UNITED STATES PATENT AND TRADEMARK OFFICE

APPLICATION NO.	FILING DATE	FIRST NAMED INVENTOR	ATTORNEY DOCKET NO.	CONFIRMATION NO.
09/674,600	12/13/2000	Lorenz Camenzind	P/543-103	1539

Office Action Summary	Application No. 09/674,600	Applicant(s) CAMENZIND ET AL.	
	Examiner Gail Verbitsky	Art Unit 2859

DETAILED ACTION

FIG. 8b

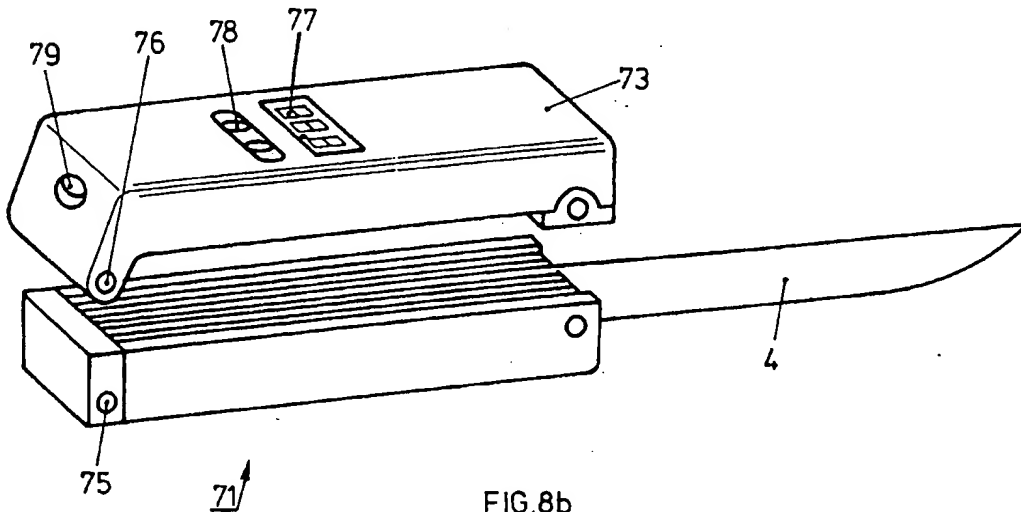
1. The disclosure is objected to because of the following informalities: A) the numeral should be given to the casing in Figs. 2 and 8b and described in the specification. (see paragraph 2).

2. The drawings filed on 02/02/2007 are objected to because the numeral should be given to **the casing** in Figs. 2 and 8b. Corrected drawing sheets in compliance with 37 CFR 1.121(d) are required in reply to the Office action to avoid abandonment of the application. Any amended replacement drawing sheet should include all of the figures appearing on the immediate prior version of the sheet, even if only one figure is being amended. The figure or figure number of an amended drawing should not be labeled as "amended." If a drawing figure is to be canceled, the appropriate figure must be removed from the replacement sheet, and where necessary, the remaining figures must be renumbered and appropriate changes made to the brief description of the several views of the drawings for consistency. Additional replacement sheets may be necessary to show the renumbering of the remaining figures. Each drawing sheet submitted after the filing date of an application must be labeled in the top margin as either "Replacement Sheet" or "New Sheet" pursuant to 37 CFR 1.121(d). If the changes are
